# UNITED STATES PATENT AND TRADEMARK OFFICE

APPLICATION NO.	FILING DATE	FIRST NAMED INVENTOR	ATTORNEY DOCKET NO.	CONFIRMATION NO.
10/051,602	01/17/2002	William A. Baker	5893.02	1121

**Office Action Summary**

## DETAILED ACTION

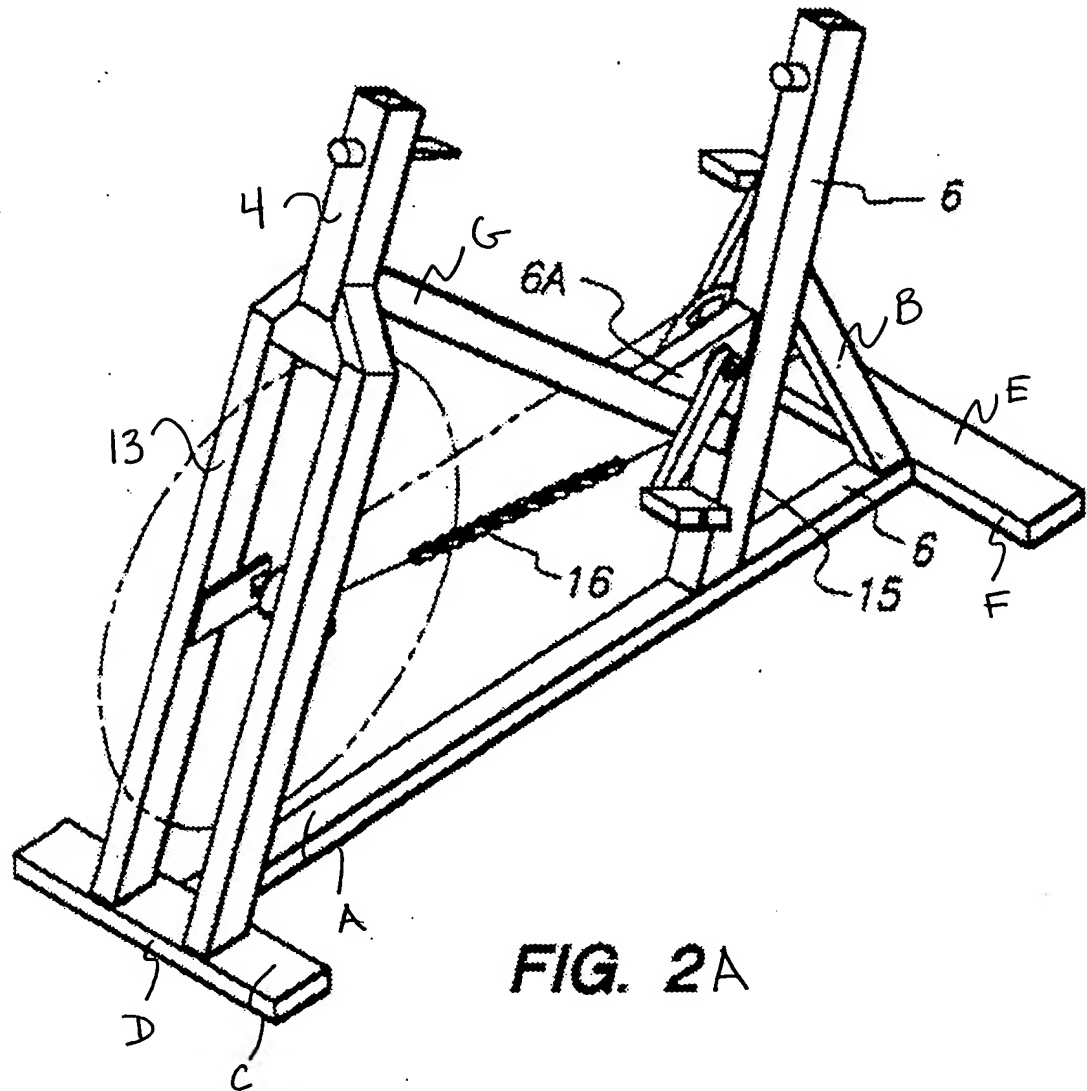
2. As to claim 1, Goldberg discloses a frame comprising an upper front end (4), a lower front end (A), a rear end (B) and a set of forks (13) wherein the upper front end is attached to the forks and the lower front end is in a fixed position relative to the forks (see Fig. 2A below). Goldberg does not disclose that the frame is of a monoframe/monocoque construction. Bowden discloses an exercise bicycle having a frame of monocoque construction wherein the skin of the frame carries a major part of the stresses applied to the frame (see Figs. 1, 2 & 11 and Col. 1, lines 41-46). At the time of the invention, it would have been obvious to a person of ordinary skill in the art to make Goldberg's frame from semi-monocoque components since monocoque frames

*Fig. 1B*

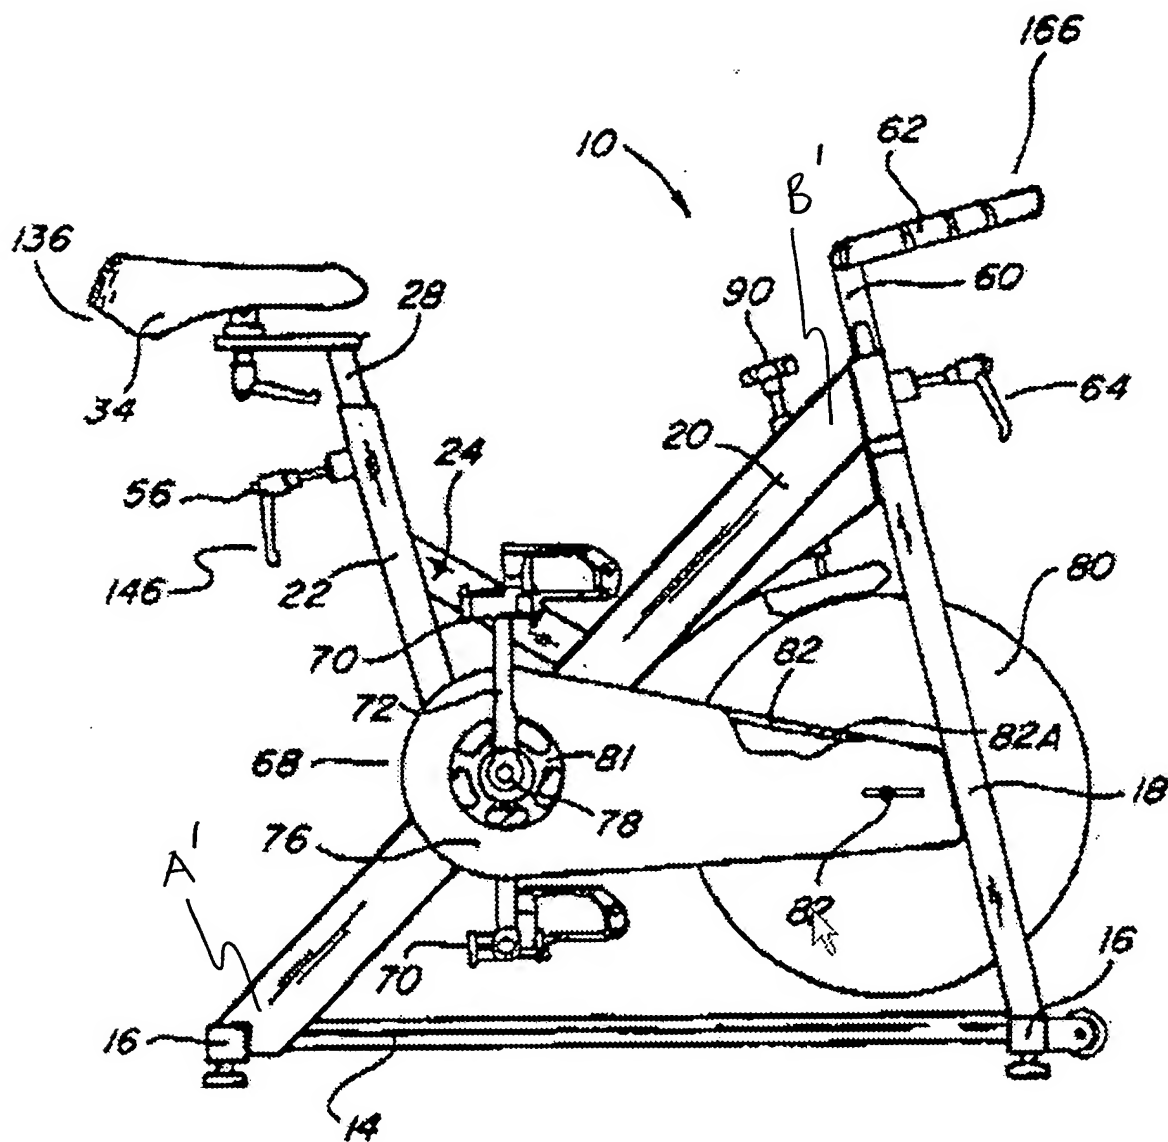
6. As to claim 10, Forcillo discloses a frame for an exercise bicycle comprising a frame comprising a rear support (A'), a top support (B'), a seat support (22) and a seat tube (28) partially received within the seat support (see Fig. 1B below). Forcillo does not disclose that the frame is of a monocoque construction. Bowden discloses an exercise bicycle having a frame of monocoque construction (see Figs. 1, 2 & 11 and Col. 1, lines 41-46). At the time of the invention, it would have been obvious to a person of ordinary skill in the art to make Forcillo's frame from semimonocoque components since a monocoque frame is relatively lighter than a traditional frame while providing functionally equivalent support and resistance to compression and shear forces. Forcillo does not disclose a bottom tube connected to the seat tube at a connection point wherein the frame member encloses the connection point. Huang discloses a bicycle frame having a seat support and adjustment means that include a seat tube (30) at least partially received within a seat support (11, C') and a bottom tube (20) connected to the seat tube at a connection point (D') wherein the frame member encloses the connection point (see Figs. 1C & 2C below). At the time of the invention, it would have been obvious to a person of ordinary skill in the art to substitute Forcillo's seat support and adjustment means (28, 146) with Huang's seat support and adjustment means since they are functionally equivalent in providing a stable support and quick height adjustments to the seat.

8. As to claims 16 and 17, Forcillo, Bowden and Huang disclose a modified frame as described above (see discussion of claim 11). Forcillo further discloses a bottom support (14) extending forward from a rear support and a front fork assembly (18) that is connected with the bottom support (14) and a top support (B') (see Fig. 1B above).

11. As to claims 29 and 30, Forcillo, Bowden, Huang and Harris disclose a modified frame as described above (see discussion of claim 28). Forcillo further discloses that the frame panels each include an aperture for receiving a bottom bracket (78) that is connected with the seat tube wherein the bracket is configured to support a drive train (see Fig. 1B above).

**FIG. 2D**

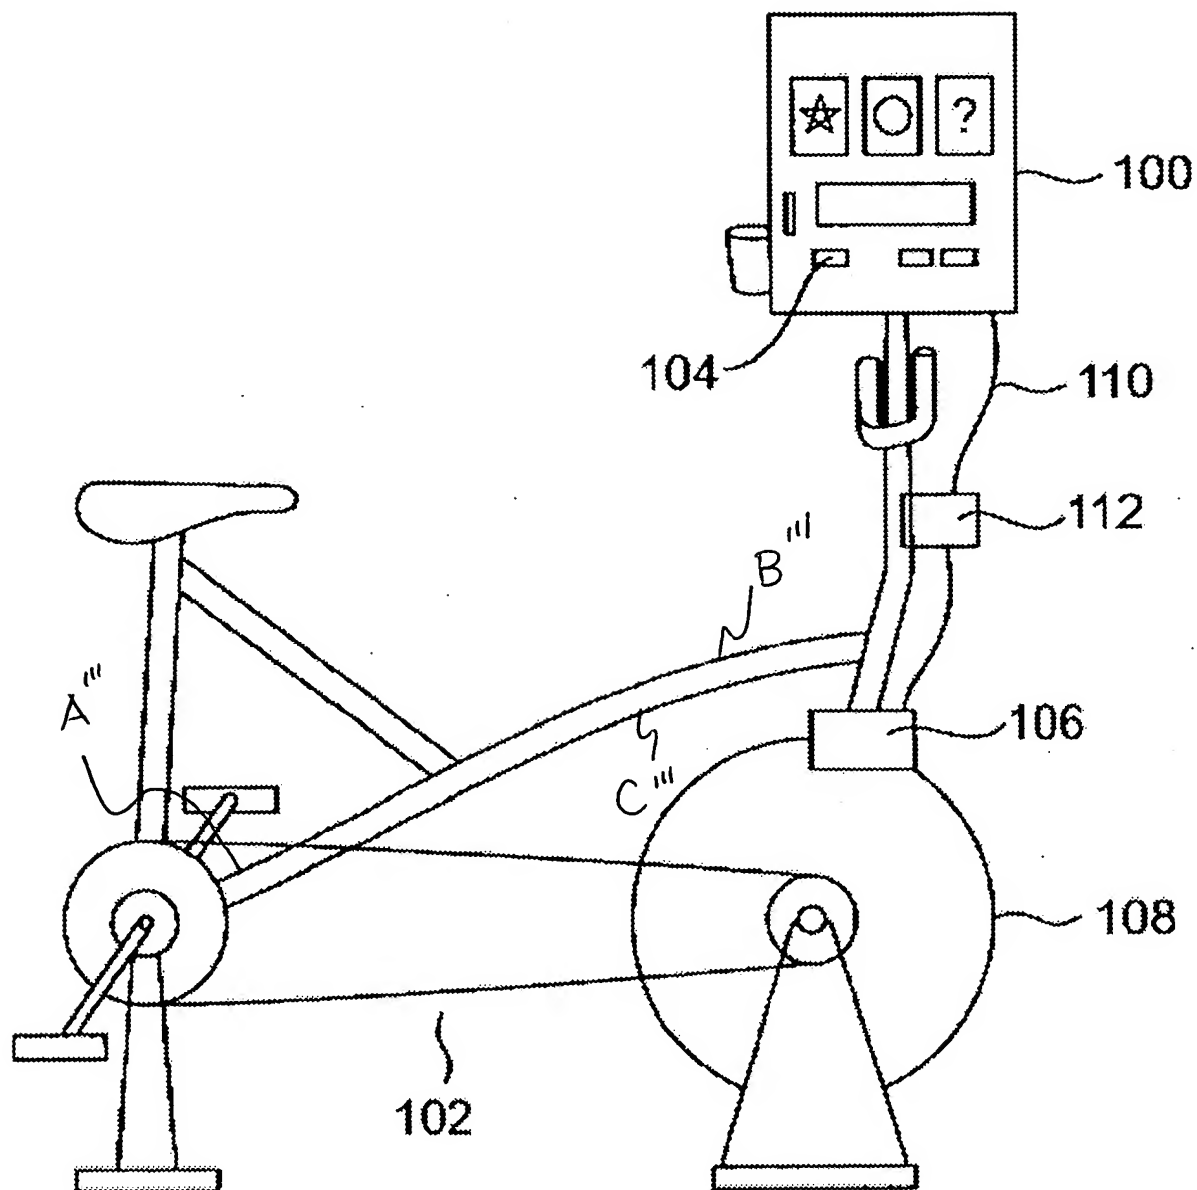
12. As to claims 12, 13, 18, 19, 31 and 32, Forcillo, Bowden and Huang disclose a modified frame as described above (see discussion of claims 10 and 16). Forcillo does not disclose that the rear, top and bottom supports define an upper convex wall and a lower convex wall such that the lower concave surface of the top support intersects the top concave surface of the bottom support. Harris et al. disclose an exercise device having a frame that includes an upper convex wall (B''') and a lower concave wall (C''') (see Fig. 2D below). At the time of the invention, it would have been obvious to a person of ordinary skill in the art to make Forcillo's rear, top and bottom supports to have concave and convex characteristics since those characteristics are known in the exercise art and Forcillo and Harris' shaped components are functionally equivalent in providing a rigid support. Furthermore, a change in the shape of a prior art device is a design consideration within the skill of the art. In re Dailey, 357 F.2d 669, 149 USPQ (CCPA 1966).

FIG. 1E

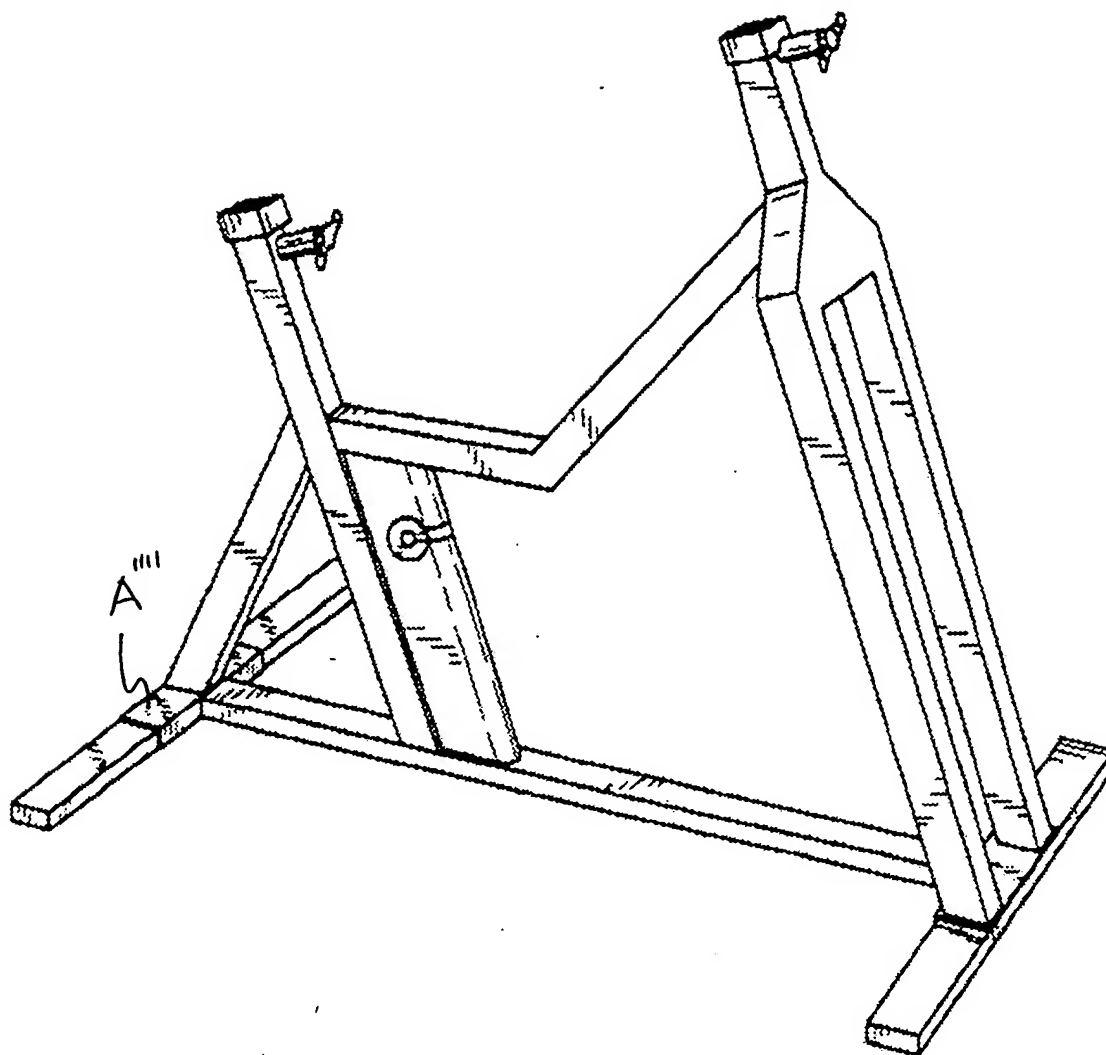
13. As to claims 14 and 15, Forcillo, Bowden, Huang and Harris disclose a modified frame as described above (see discussion of claim 13). Forcillo does not disclose a frame that includes a rear plate as substantially claimed. Luull et al. disclose an exercise device having a frame that includes a rear plate (A''') extending transversely from the rear support to laterally support the frame wherein the plate is attached to both the lower concave wall and the upper convex wall (see Fig. 1E below). At the time of the invention, it would have been obvious to a person of ordinary skill in the art to add such a plate to Forcillo's frame to provide a more stable connection between the frame and transverse foot supports.
